**Medway Planning & Economic Development Board
Meeting**

**Master's Touch Minor Site Plan Public
Briefing – 83 Main Street**

**Re: Master's Touch
Minor Site Plan Review
83 Main Street
Medway, Massachusetts**

EROSION CONTROL & DEMOLITION PLAN

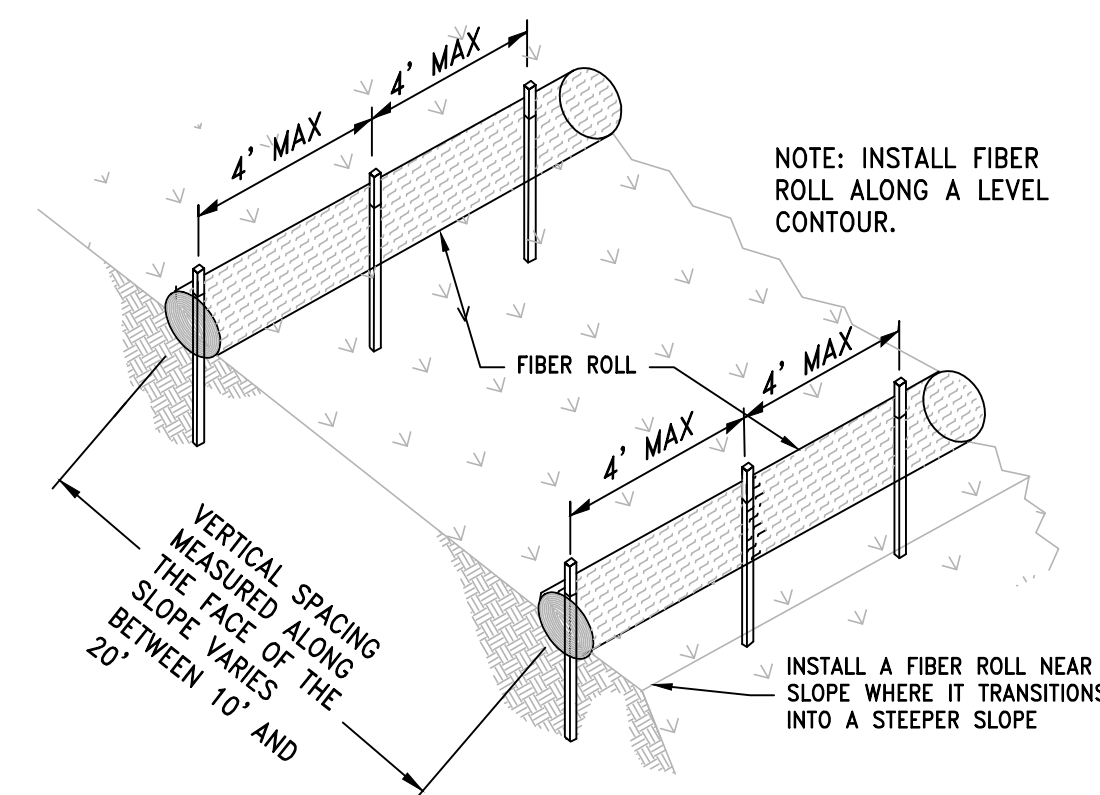
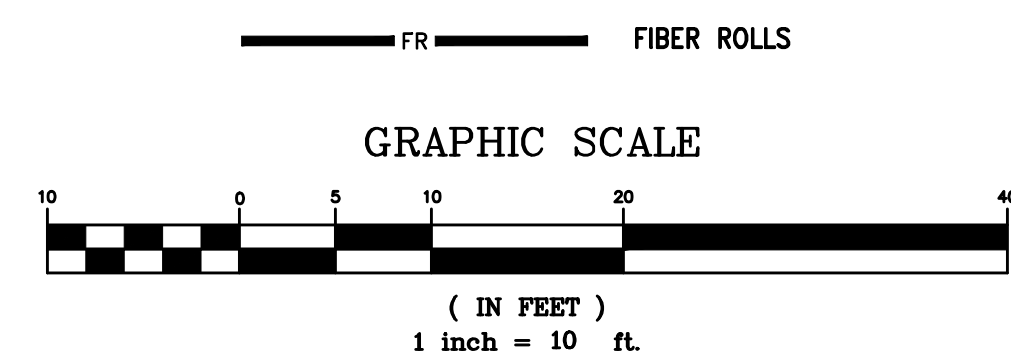
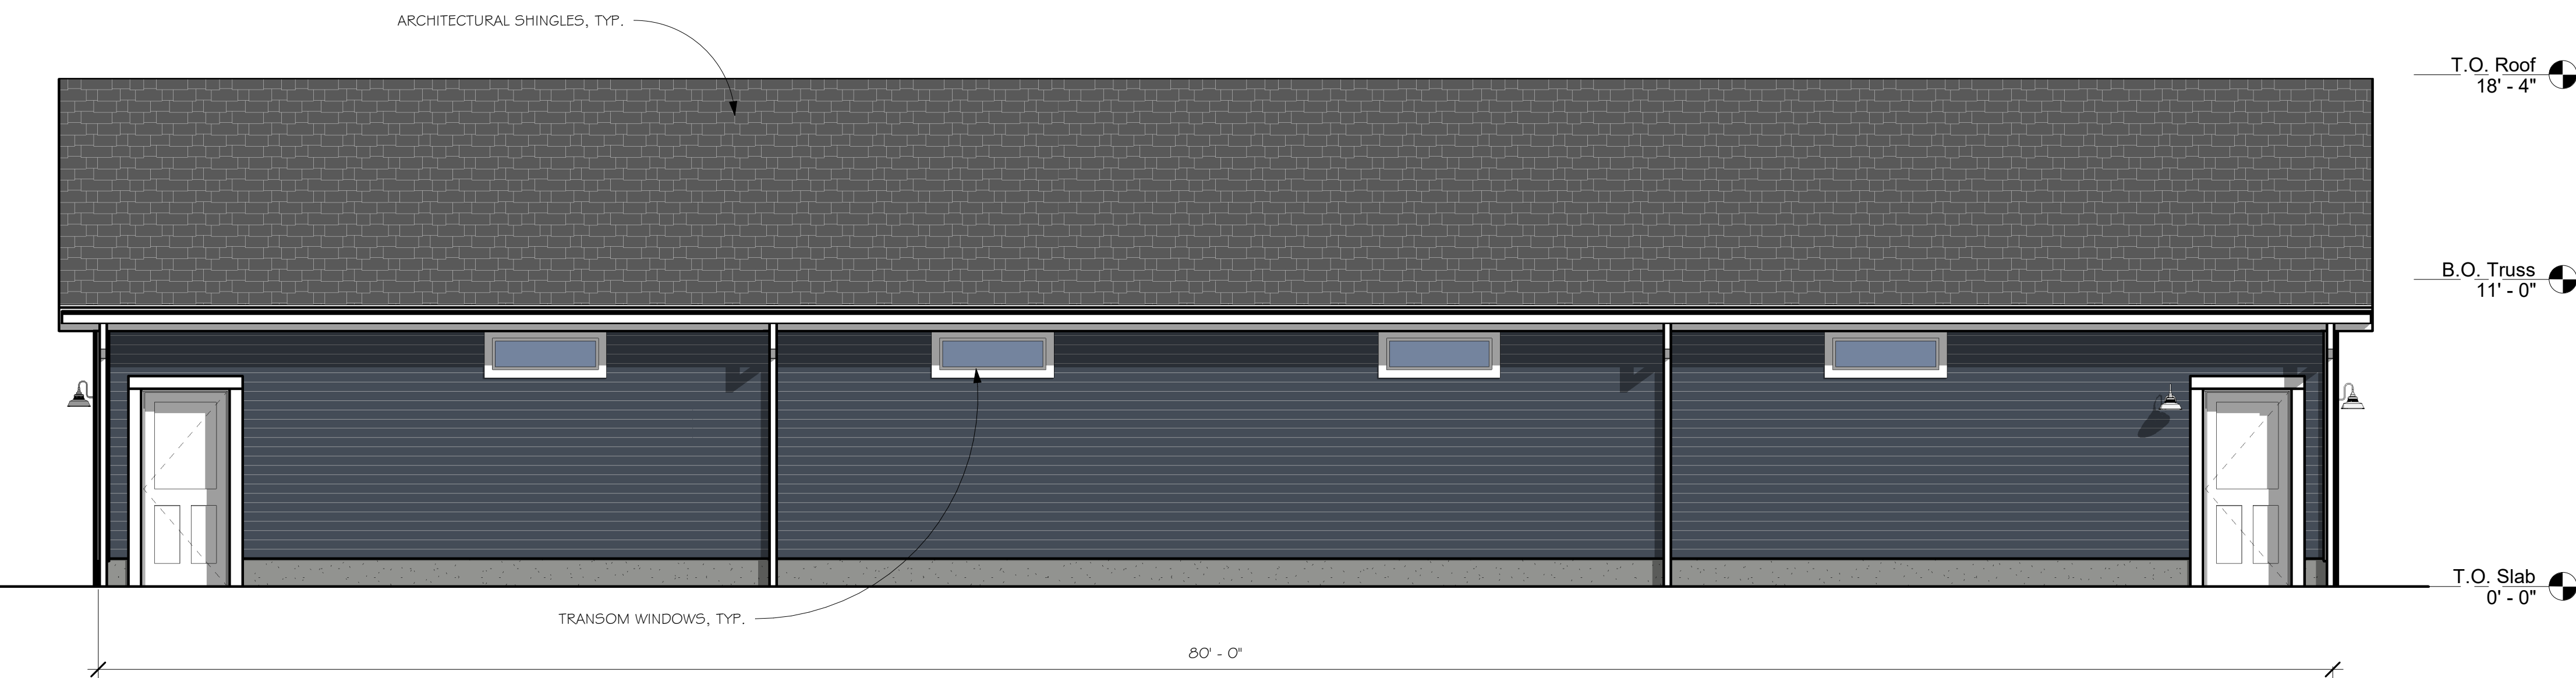
49. The Applicant has provided an Erosion Control & Demolition Plan. However, additional information is required consistent with the Bylaw such as earthwork volumes, drainage patterns, limit of work area calculation, sequence of development operations and construction term maintenance schedule. (§26.5.6.3)

50. The Applicant has not provided a Stormwater O&M Plan describing inspection requirements and maintenance procedures for BMP's during construction as well as inspection interval requirements and required reporting (bi-weekly and post 0.25 inch storm). (§26.5.7)
